Log # TXX-4478
File # 10010
TEXAS UTILITIES GENERATING COMPANY
SKYWAY TOWER • 400 NORTH OLIVE STREET, L.B. 81 • DALLAS, TEXAS 75201

SUBJECT: COMANCHE PEAK STEAM ELECTRIC STATION
DOCKET NOS. 50-445 AND 50-446
RESPONSE FOR REQUEST FOR ADDITIONAL
INFORMATION ON SAFE SHUTDOWN AND
ALTERNATE SHUTDOWN

Attachment 1 provides the responses to NRC Auxiliary System Branch
Questions 010.32 and 010.33 requested in NRC letter dated March 8, 1985.
These responses will be included in a future amendment to the CPSES FSAR.

Also attached (Attachment 2) are marked up copies of the referenced
sections of the CPSES Fire Protection Program Review (FPPR).

FIGURE 4-1

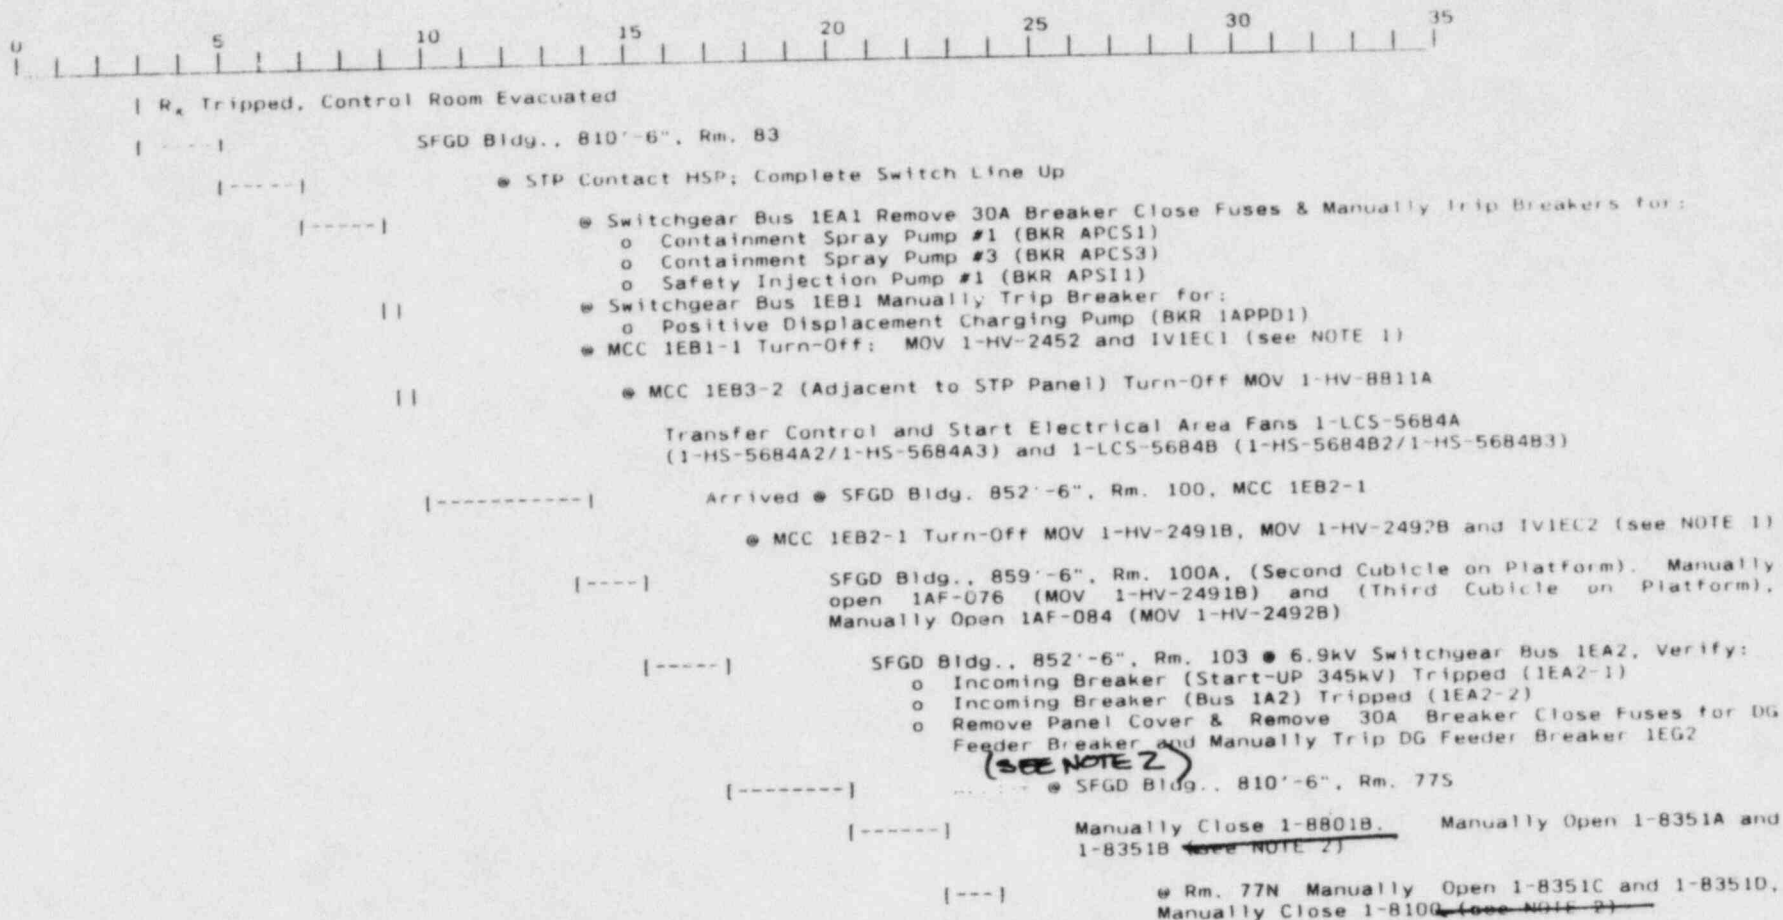
In order to complete our evaluation, we require a description of the post fire operator actions that include the priority of the operator actions, the number of actions, and the time allowed for each action. In addition, verify that these operator actions are listed in the safe shutdown procedures.

Priority of operator actions and the time allowed for each operator action are given in FPPR Figures 4-2 and 4-1, respectively.

NOTE 1: ~~The following valves will be deenergized at the specified MCC:~~

~~1EB1-1~~
Tripping IVIE1 @ MCC 1EB1-1 deenergizes the AC input to the inverter. The inverter supplies power to ICS-8220 & the I/P converters that control SG PORVs 1PV2325 & 1PV2327.

~~1EB2-1~~
Tripping IVIE2 @ MCC 1EB2-1 deenergizes the AC input to the inverter. The inverter supplies power to ICS-8221 and the I/P converters that control SG PORVs 1PV2326 & 1PV2328.
